SEWAGE DISPOSAL SYSTEM

MARYLAND STATE DEPARTMENT OF HEALTH

SUBDIVISION Russell Coleman Property ROAD 14570 Triadelphia Rd LOT 17

SITE PLAN
Lot 17
RUSSELL COLEMAN PROPERTY
OWNER ROBERT LONG & WIFE
5TH ELEC. DIST. HOWARD CO. MARYLAND
1"=100' 3-30-86

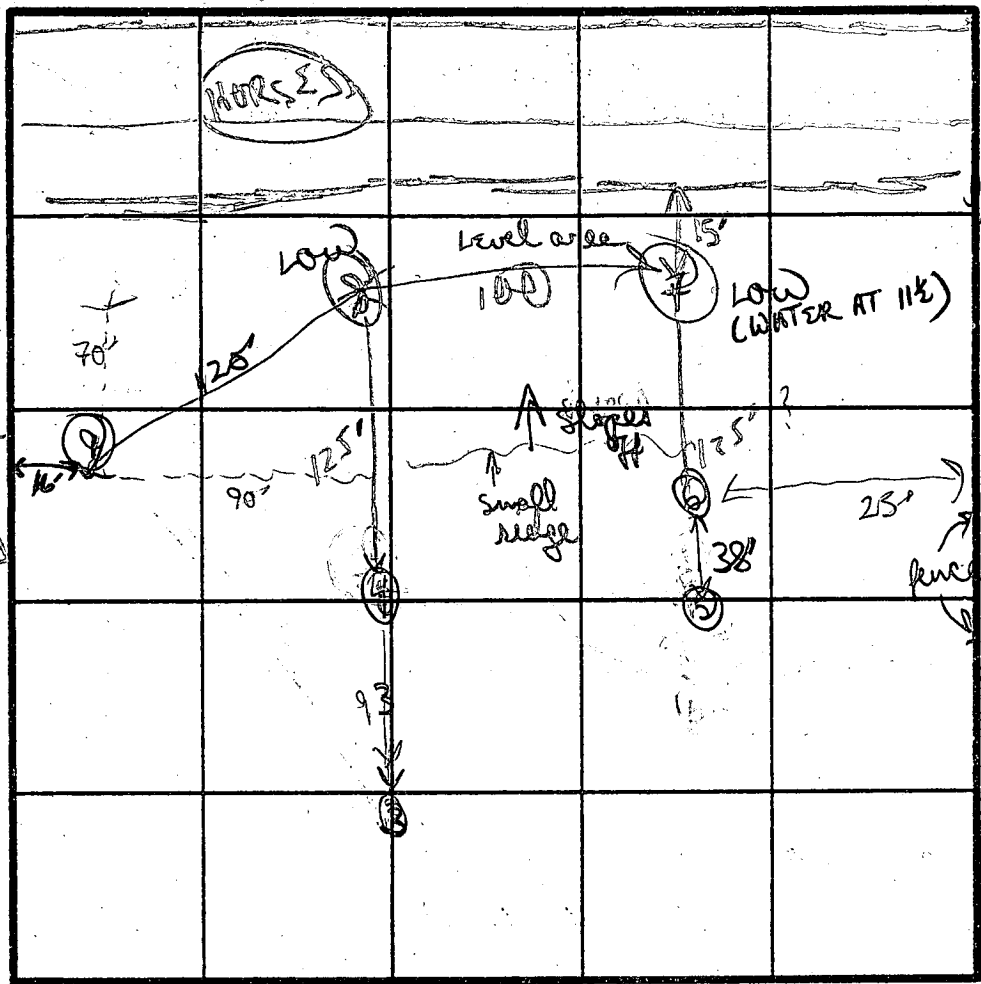
1 new low hole (#7) had H₂O as did holes 6+5 (all in same line)

REMARKS All other holes tested out OK so suggest switching pore fields

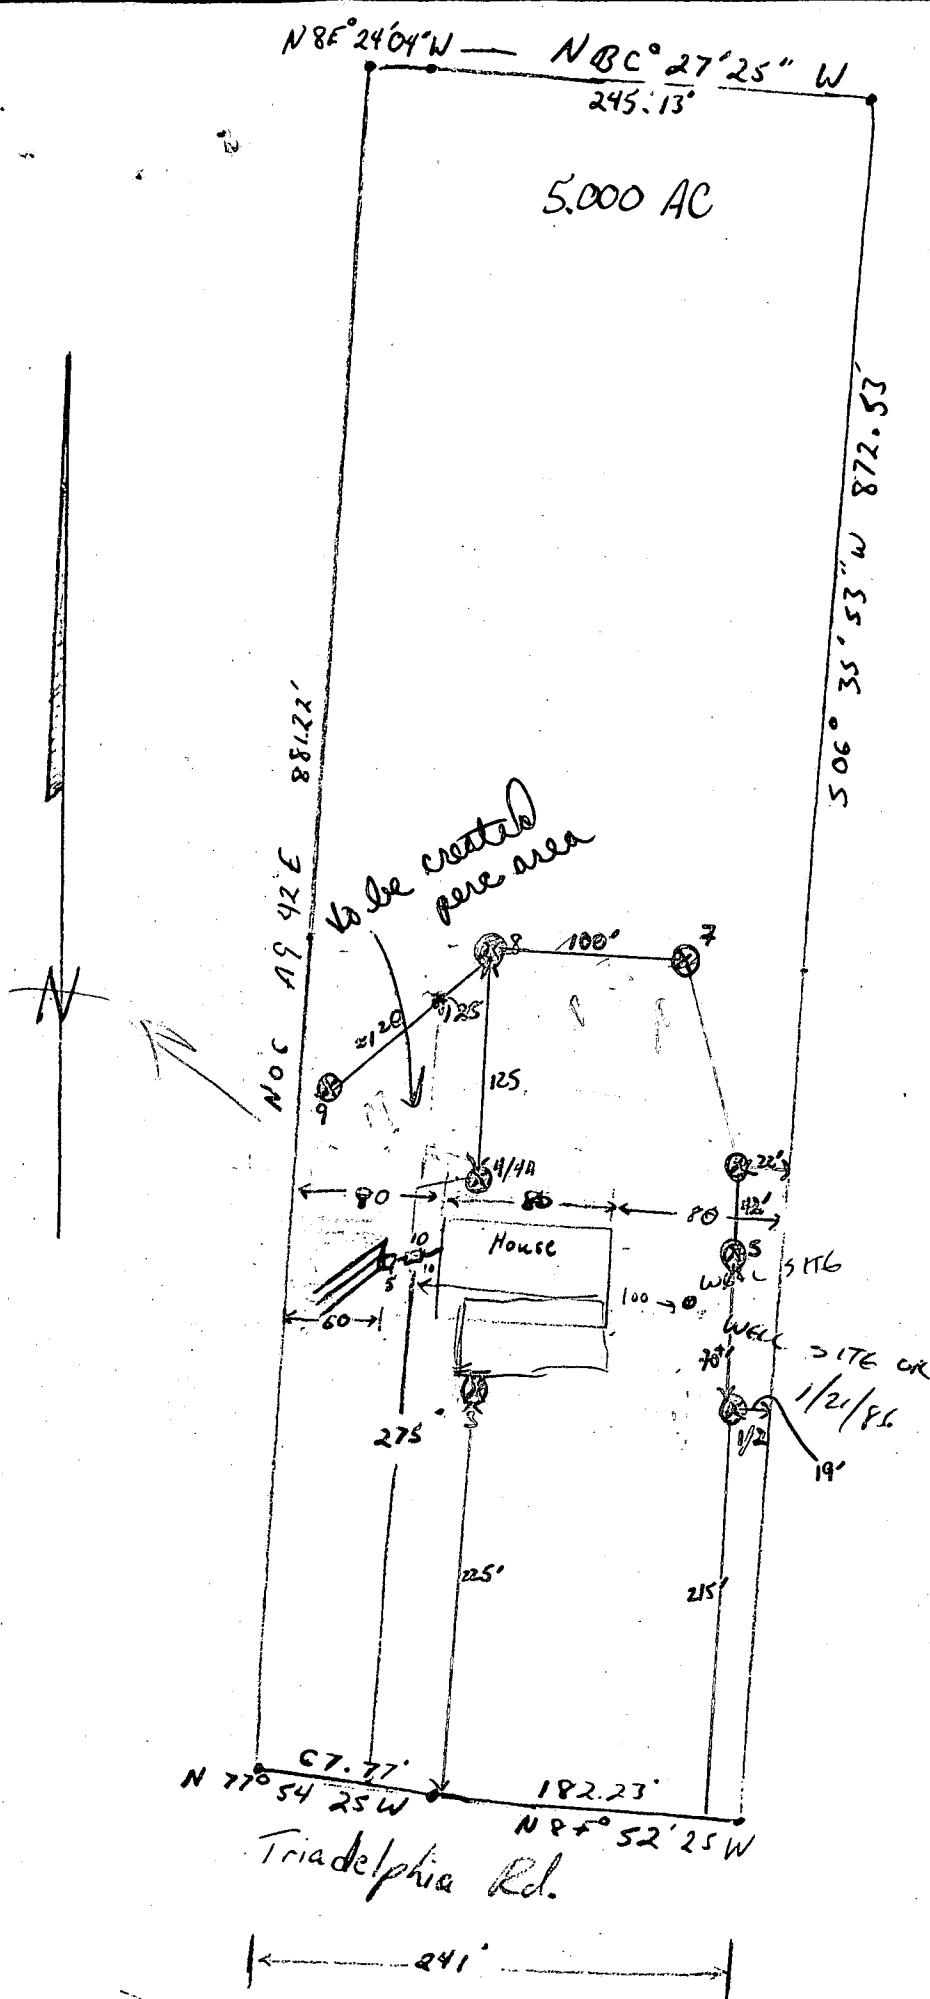
DISTRIBUTION BOX DIVIDING LENGTH
100' length maximum
NEED 170' TRENCH

If house is
 shifted ($\approx 10-20'$) to
 the right, should
 yield 10,000 +
 easier trench access.

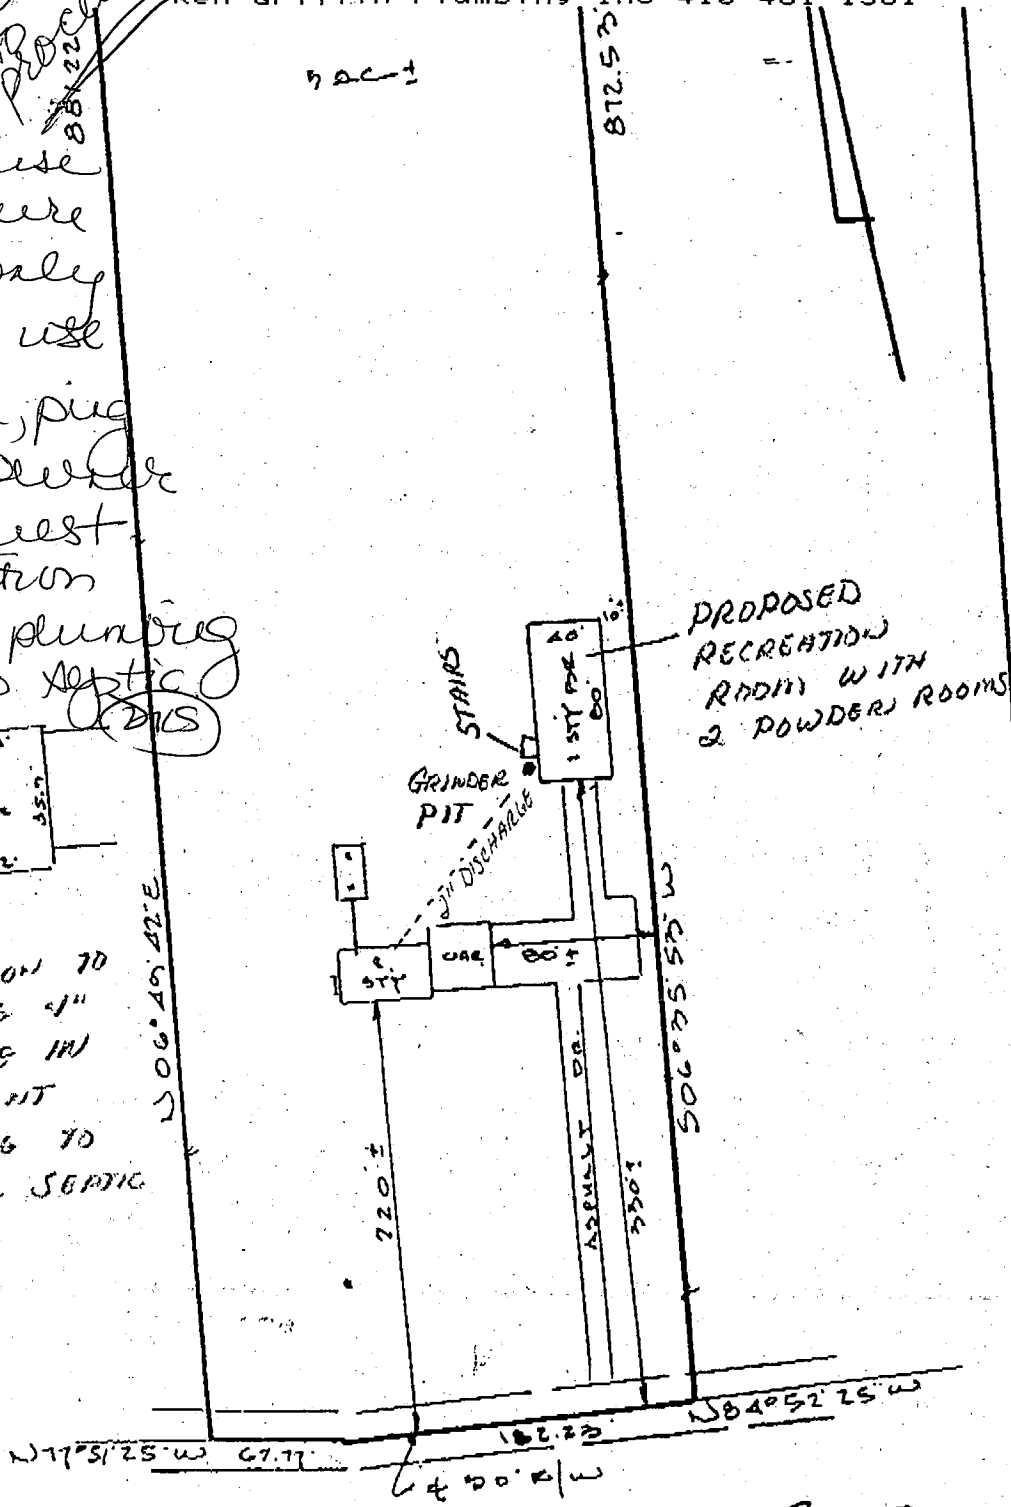
Per owner,
intended use
for structure
shall be only
for family use
(pool table, ping
pong, etc). Owner
shall request
HD inspection
at time of plumbing
look up to septic

OK
PROCEED

ACCT #
D54570
SITE PLAN

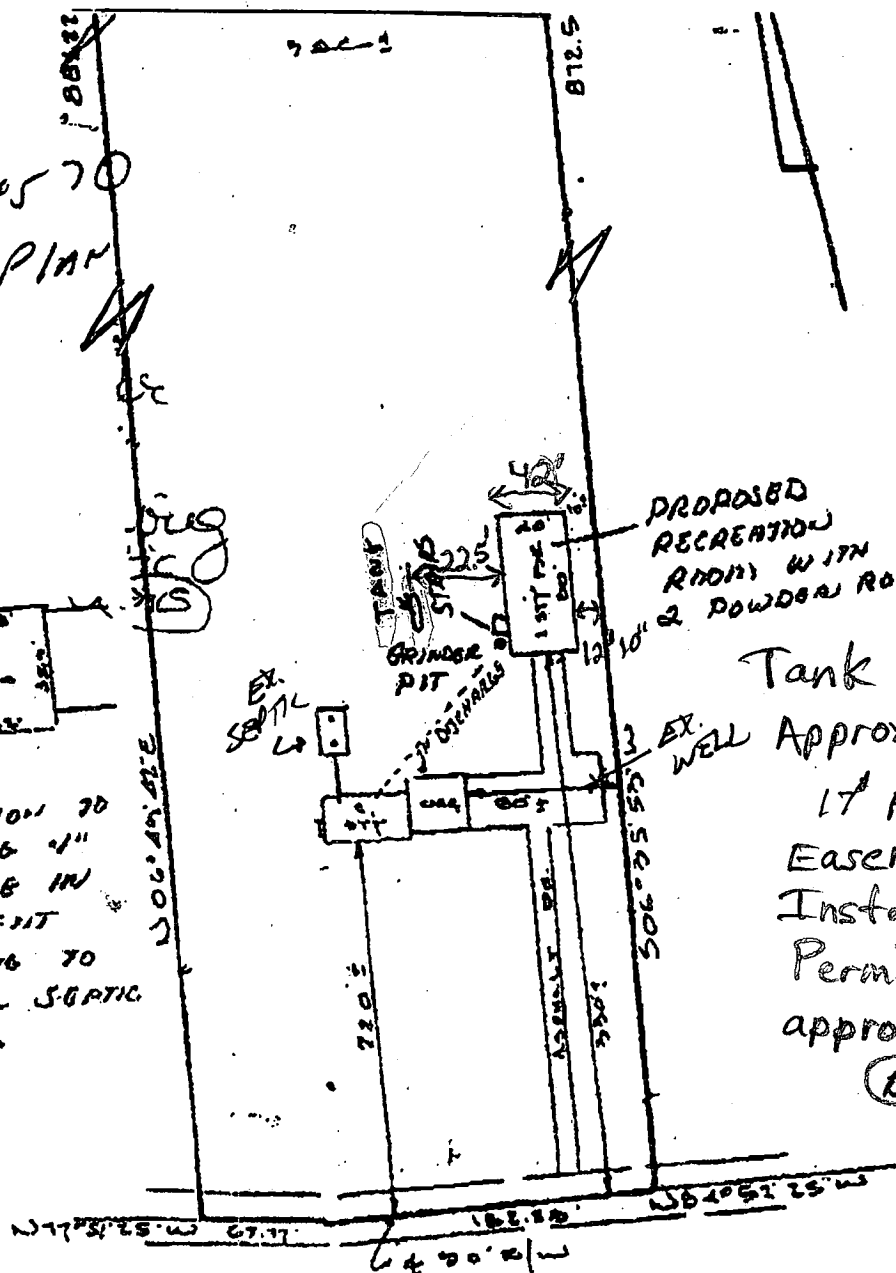
Approximately
17' From
Easement
Installed Before
Permit. Will
approve as is.
